TECHNICAL SERVICE BULLETIN

Technical Service Bulletin: 220-2002
EXPIRATION DATE: November 30, 2026

TECHNICAL SERVICE BULLETIN 220-2002 REMEDY INSTRUCTIONS

2026 APEX MODELS: APTT241BHS, APTT242BARV, APTT244RBS, APTT246BARV, APTT291TBSS

FIGURE 1

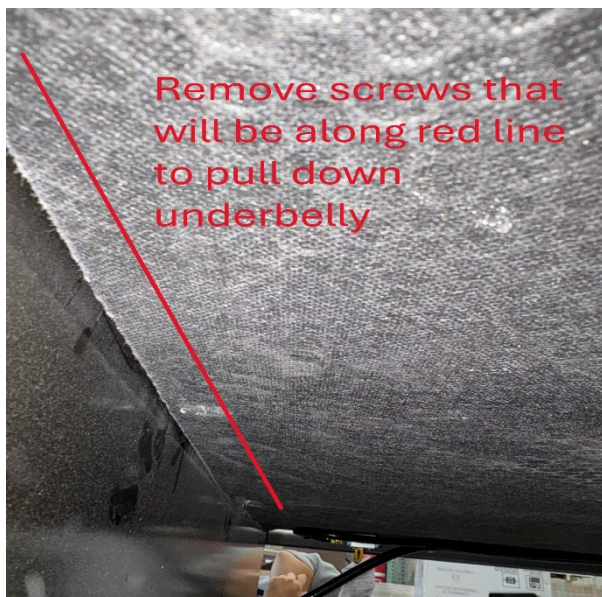
STEP 1: REMOVE THE FRONT SCREWS OF THE UPPER UNDERBELLY WHERE THE FRAME DROP MEETS THE UPPER FRAME (REFER TO FIGURE ONE)

FIGURE 2

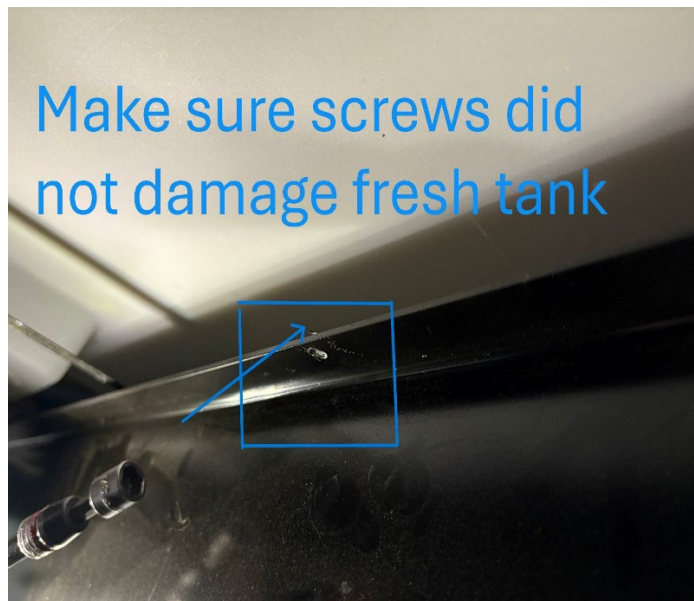
STEP 2: PULL DOWN FRONT EDGE OF UNDERBELLY AND INSPECT THE FRESH TANK ABOVE ANY CENTER LOCATED SCREWS FOR POTENTIAL DAMAGE. (REFER TO FIGURE 2)

A. IF NO DAMAGE IS FOUND PROCEED TO STEP 3.

B. IF DAMAGE TO THE TANK IS FOUND, CONTACT CUSTOMER SERVICE AND ORDER A NEW TANK. REPLACE THE TANK AND MOVE ON TO STEP 3.
